MEMORANDUM TO: Samuel J. Collins, Director
Office of Nuclear Reactor Regulation

FROM: Ashok C. Thadani, Director *Ashok C. Thadani*
Office of Nuclear Regulatory Research

SUBJECT: ELECTROSLEEVE REPAIR OF DEGRADED STEAM GENERATOR
TUBES

SUBJECT: FAILURE PREDICTION OF ELECTROSLEEVED TUBES UNDER
SEVERE ACCIDENT CONDITIONS

Figure 1 Predictions and Test Results

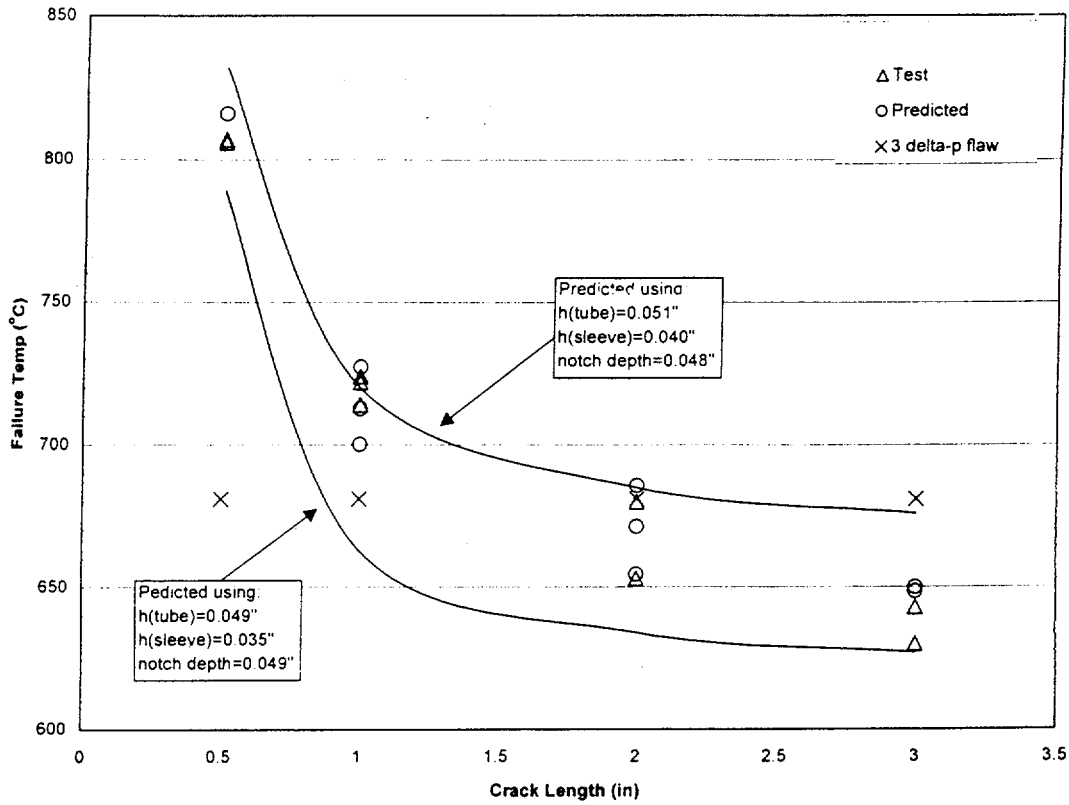
Figure 1 presents the test data along with model predictions for the tested tubes. Also, failure prediction curves are shown for tube and flaw geometries that are slightly larger and smaller than the nominal tube and sleeve dimensions. In addition, the failure temperature (681°C) is shown for unrepaired tubes with flaw lengths of 0.5, 1.0, 2.0, and 3.0 inches and part-through wall depths of 76.6 percent, 67.1 percent, 62 percent, and 60 percent, respectively. These correspond to degraded tubes that just fail at 3 delta-p under normal operating temperature, and might remain in service at the end of a given operating cycle. The behavior of these 3 delta-p flawed tubes is seen to fall within the predictions and test results for electrosleeved tubes with flaws entirely through the parent tube.

Based on these test results, the staff has concluded that the failure model provides a reasonable estimate of the tube failure temperatures. The failure curves, which are based on anticipated variation in tube and sleeve dimensions appear to do a good job of bounding these test data. A more rigorous treatment of the data will be performed as the remaining tests are completed and the data analyzed.
